SERVICETEKNOTES

TABLE OF CONTENTS

The above parts are located on A38 Optical Pulse Generator board and shown on Diagram 2 OPTICAL PULSE GENERATOR - Partial

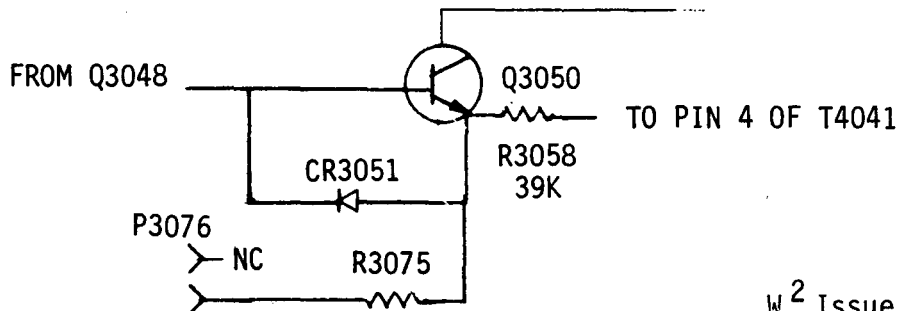
ELECTRICAL PARTS LIST AND SCHEMATIC CHANGES

CHANGE TO:

A38C2053	290-0523-00	CAP., FXD, ELCTLT: 2.2UF, 20%, 20V
A38R3046	321-0304-00	RES., FXD, FILM; 14.3K OHM, 1%, 0.125W
A38R3050	321-0246-00	RES., FXD, FILM: 3.57K OHM, 1%, 0.125W

ADD:

A38R3058	315-0393-00	RES., FXD, FILM: 39K OHM, 5%, 0.25W
----------	-------------	-------------------------------------

475, MANUAL ERROR ON POWER DISTRIBUTION
DIAGRAM

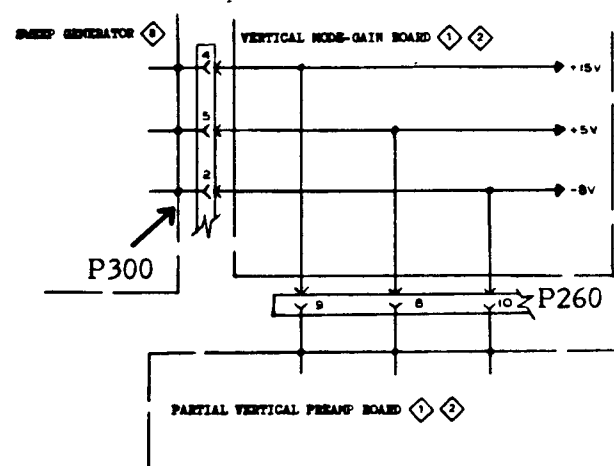
The power distribution diagram in the early 475 manual, below B250000, has an error in the power supply voltages shown on the Vertical mode--gain board. The diagram below shows the correct pin numbers and voltages.

P300, shown at the left edge of diagram 3, should be changed to show the + 5 V going to pin 5.

Change power connections on P300 and P260 as follows:

Use P/N
212-0613-00

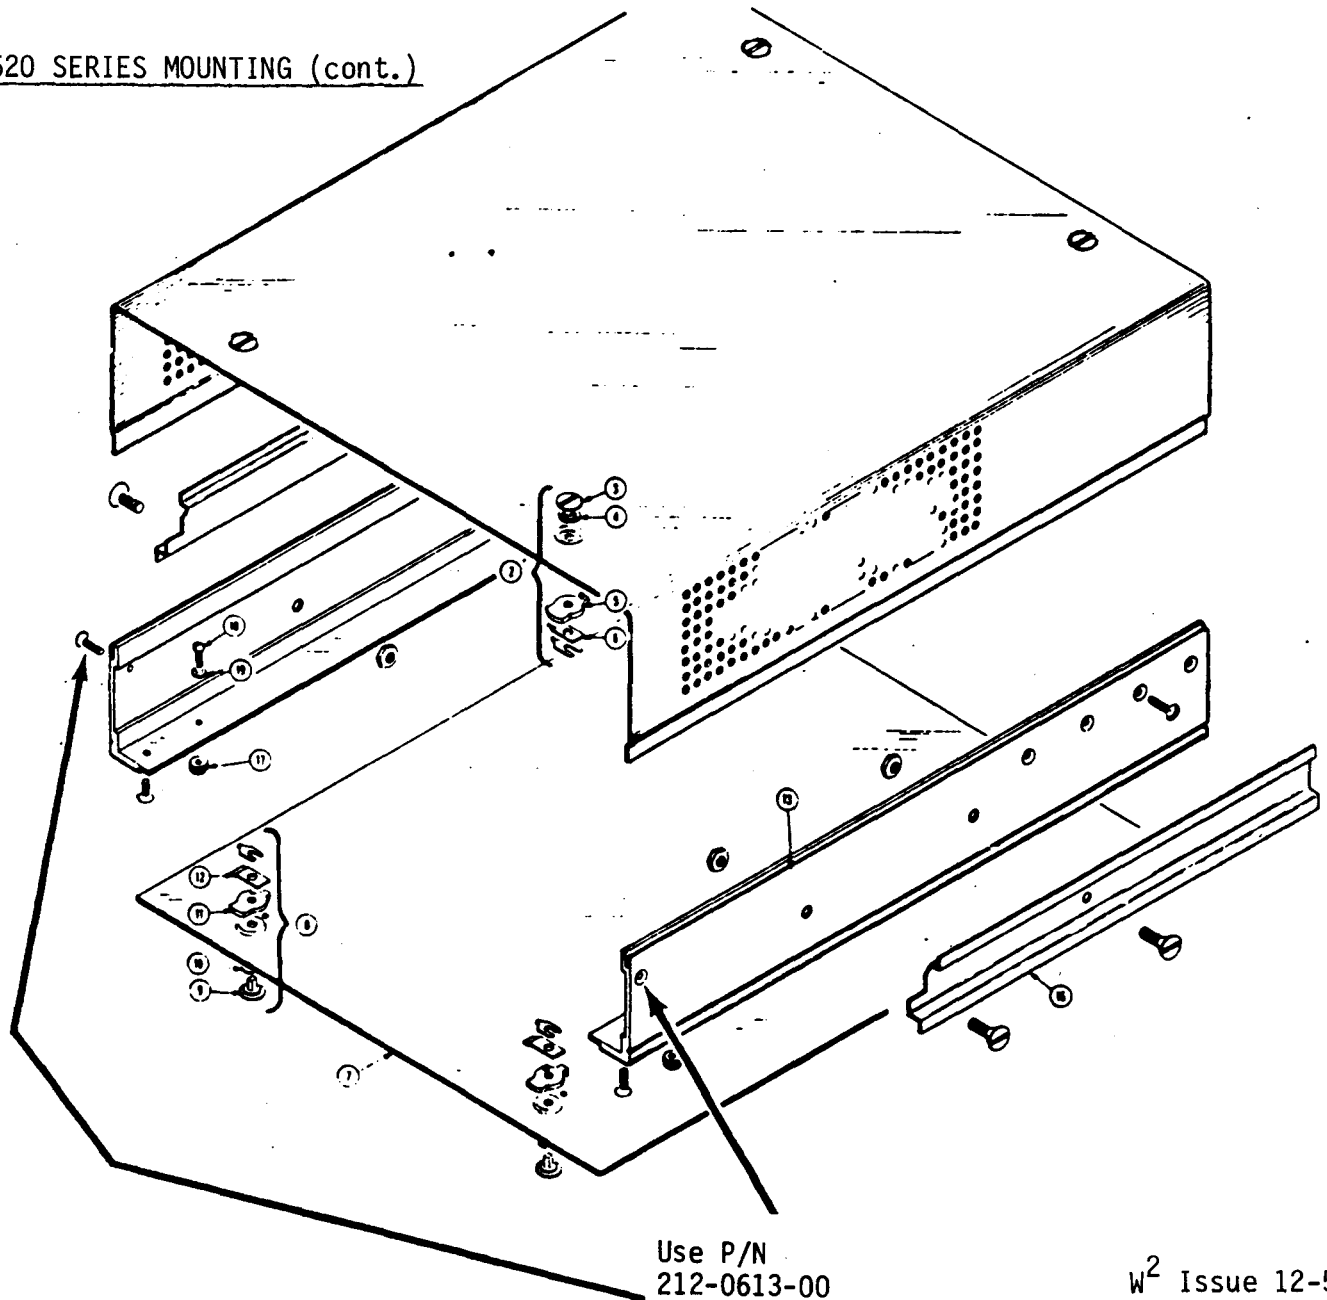
A screw of insufficient length has been used to fasten the side rails to the main chassis, causing stripped threads. Where a bad screw is found, replace with 212-0613-00 (see illustration).

DECODER BOARD
670-2611-07

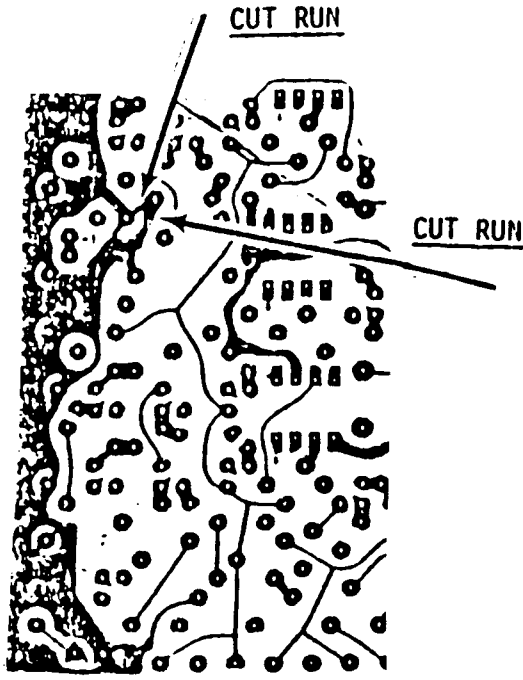
The Decoder Board (670-2611-07) has an ECB layout error which shows up as a 400KHz ripple of about 200mV P-P riding on the R-Y output. The cause is one end of R2739 being shorted to ground. The suggested fix is to cut the ground plane surrounding the bottom pad of C2641 (See illustration).

INTERIUM SOLUTION

COMPONENT SIDE OF BOARD

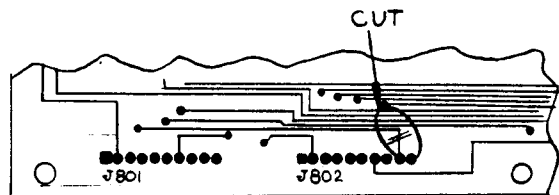
10. Connect pin 10 of J802 to pin 12 of U281.
11. Connect pin 8 of J802 to pin 19A of J301.
12. Connect pin 11 of U211 to pin 13 of U165.
13. Connect pin 11 of U165 to pin 12 of U165.
14. Cut run from pin 9 of J802. See Fig. 1

15. Connect pin 9 of J802 (run connection on backside of board) to pin 10 of U165.

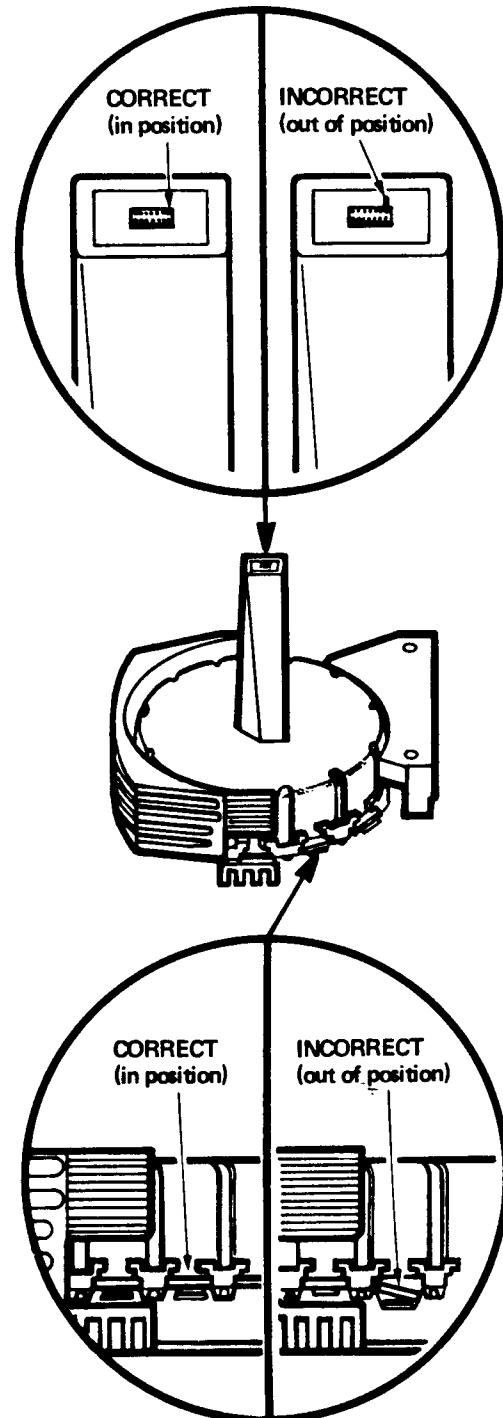
The metal plates that cause the printhead wires to move can be jarred out of position during handling or replacement.

Be sure to inspect printheads after product shipping or during printhead replacement. If a wire is protruding from the printhead, it indicates that the metal plate is lifted from its normal position. Be sure to reseat the metal plate back to its proper position. See illustration.

Figure 1

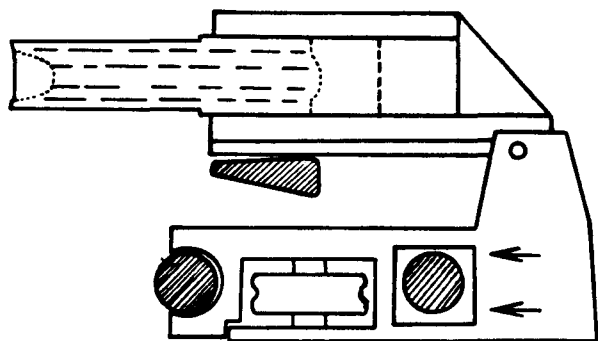
The 4662 can be visually inspected to determine if the rear of a pen carriage is positioned too high. Looking at the side of the pen carriage, observe the square hole surrounding the rear slide shaft. The slide shaft should be positioned closer to the top of the square hole. See figure 1.

Figure 2

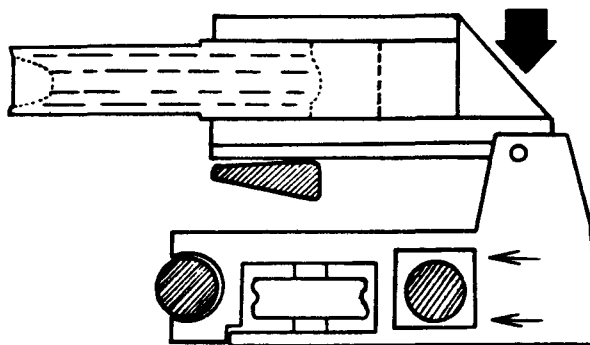
If the carriage slide shaft is located closer to the bottom of the square hole, figure 2, the pen carriage needs to be correctly positioned. This can be accomplished by placing firm downward pressure on the rear of the pen carriage just above the pivot point, see figure 2, while supporting the bottom of the carriage slide shafts to keep them from becoming bent or warped. The downward pressure should cause the pen carriage to snap back into its normal operating position.
